DATE ~~R~~ Jun.30/03**V2500-A1/A5 SERIES PROPULSION SYSTEMS SERVICE BULLETIN**

This document transmits Revision 1 to Service Bulletin EV2500-71-0271 and
 Revision 1 to the Supplement

Reason for change
 Correction to P Clip part
 Number in Fig.1 Sheet 3 of
 3.

ENGINE - ENGINE VIBRATION MONITOR (E.V.M.) HARNESS - RE-ROUTING OF THE E.V.M. HARNESS
AT CLIPPING POINTS CP0876 AND CP1210

Rerouting of the E.V.M. Harness
Figure 1 (Sheet 1 of 3)

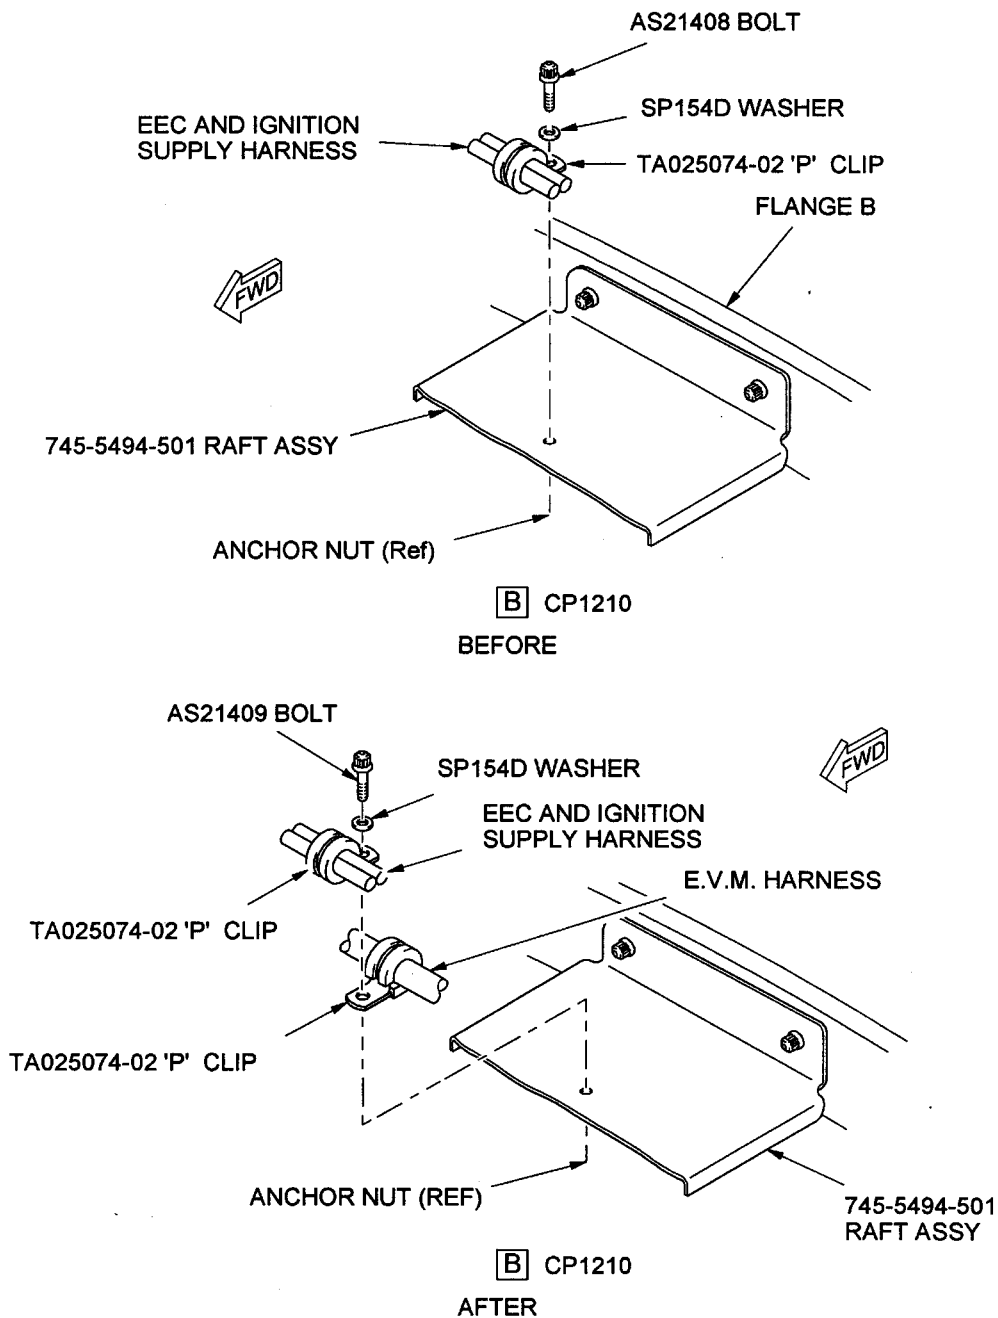
- (1) Remove the AS21408 Bolt and the SP154D Washer to disassemble Clipping Point CP1210. Refer to Figure 1 view B - before.
- (2) Remove the AS21410 Bolt, the SP154D Washer and the AS20624 Nut to disassemble Clipping Point CP0876. Refer to Figure 1 view C - before.

- (3) Remove the forward TA025074-02 'P' Clip from the E.V.M. Harness and fit to the Harness to suit the new stack-up of the Clipping Point CP0876. Refer to Figure 1 view C.

- (4) Locate the E.V.M. Harnesses to the Raceway at Clipping Point CP0876 and install with the AS21410 Bolt, the SP154D Washer and the AS20624 Nut. Refer to Figure 1 view C - after. Hand tighten the bolt.

- (5) Fit the TA025074-02 'P' Clip to the E.V.M. Harness and install to the 745-5494-501 Raft Assembly at Clipping Point CP1210 with the AS21409 Bolt and SP154D Washer. Refer to Figure 1 view B - after. Hand tighten the bolt.

- (6) Make sure the E.V.M. Harness has a minimum clearance of 0.250 in. (6,35 mm.) with adjacent structure/hardware between Clipping Points CP0877 and CP0875. Refer to the A320/V2500-A1, A320/A321/V2500-A5 Engine Manual (E-V2500-1IA) for details on harness clearances. Refer to Figure 1.
